# MIAMI BEACH

### Staff Report & Recommendation

### Design Review Board

SUBJECT: DRB17-0160  
**1420 Bay Road—The Grand Flamingo**

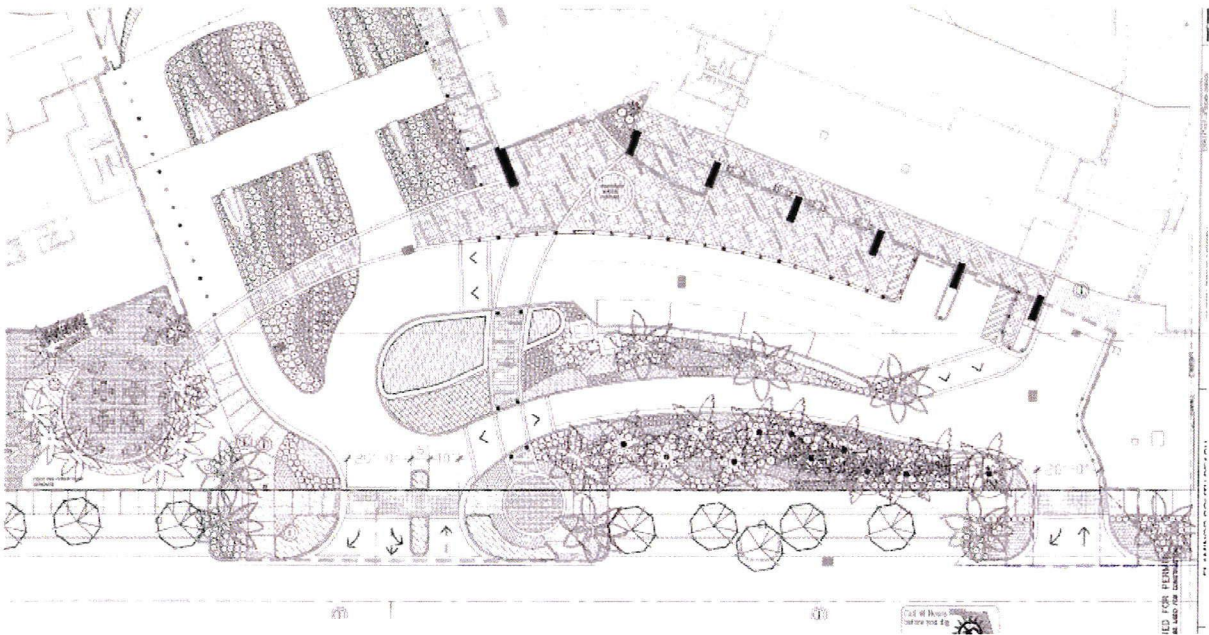
Traffic conflicts and circulation problems unquestionably exist at this development's front entrance location along Bay Road, which currently appears as a continuation of 15<sup>th</sup> Street due to the extensive width of the curb cut. These conflicts are partially due to the built environment and prior building permits, and partially due to stringent access enforcement at the gatehouse at the direction of the Flamingo management. Concerns over security issues have arisen from the residential development with over 1,680 apartment units with multiple points of entry and serious traffic flow disruption. This has led to an escalating enforcement of entry and access into what was once the primary, vehicular motor court to two (2), densely populated towers. The approval of the 35-story addition in 1997, also contemplated the vehicular flow "through and around" the central oval motor court. The traffic conflicts and circulation problems began after the completion of the central tower, and have only escalated with the advent of ride-sharing services and further dependency on instant delivery of goods. Ride-sharing and/or taxi waiting areas simply were not contemplated at the time of completion. After numerous meetings over the years with many City representatives from various departments including Planning, Parking, Public Works, Police and Transportation, as well as with concerned and affected neighbors, short term solutions have been tested, including on-street taxi queuing areas, onsite traffic police guards, and the introduction of pavement striping and bollards in an effort to resolve the fundamental issue of queuing and back-up onto Bay Road.

Approved site plan October 2007 DRB File No. 20925

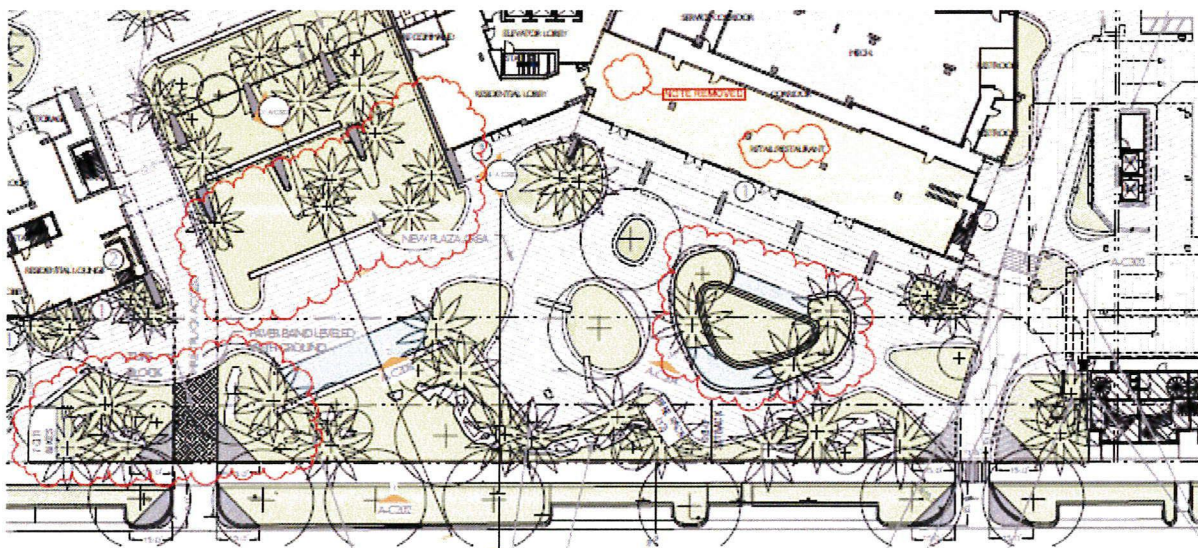
While the 2007 site plan is the scheme preferred by the Planning Department, the applicant does not wish to revisit a plan that, according to them, fundamentally does not work to improve pedestrian safety, eliminate traffic cue and work in tandem with the concept for site improvements. The applicant has stated on numerous occasions that this scheme does not work from a transportation and traffic standpoint. Further, the submitted traffic report states that “as a result of the documented deficiencies of the 2007 site plan, it is not recommended to implement the circulation plan presented in the 2007 site plan”. Staff would note the same traffic engineer company that cites the deficiencies of the plan is the same firm that designed the 2007 plan.

Revised site plan submitted DRB17-0160

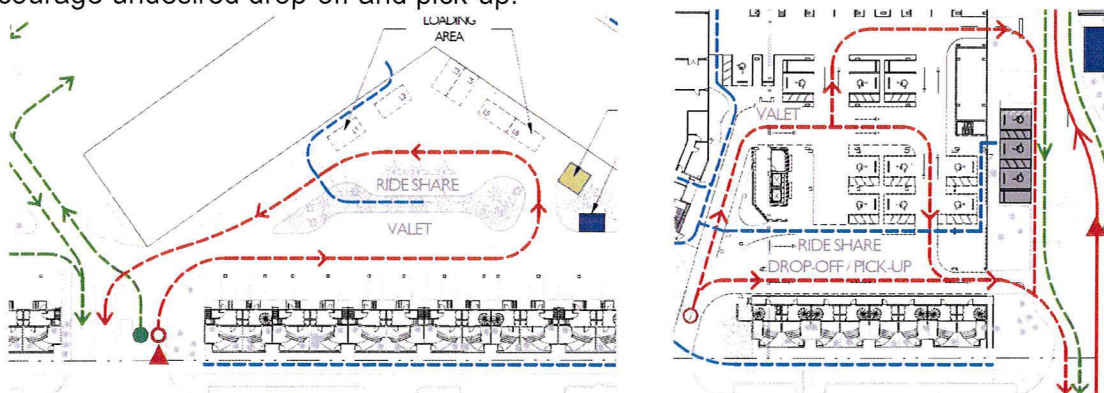
While Planning staff continues to have some reservations with the impact of the overall elimination of the central vehicular entry drive and the proposed new curb cut and dedicated

ride share user areas, the applicant maintains that the proposed dual inbound and outbound traffic configurations for each new entry/exit drive and ride sharing valet operations has some tangible benefits with regard to internal and external traffic flow. Further, the revised front entry area will introduce a new urban public plaza that will greatly improve the existing 'pedestrian unfriendly' environment with an overall increase of 6,200 SF of green space and will be open to the public and promote outdoor active open space. For security and preventative trespass into the site/courtyard area, fencing and defensive landscaping will be reintroduced but further setback under the bridge of the Central tower to ensure territorial boundaries between public and private space. Two lobbies will flank either side of the view corridor created by the 1997 35-story addition.
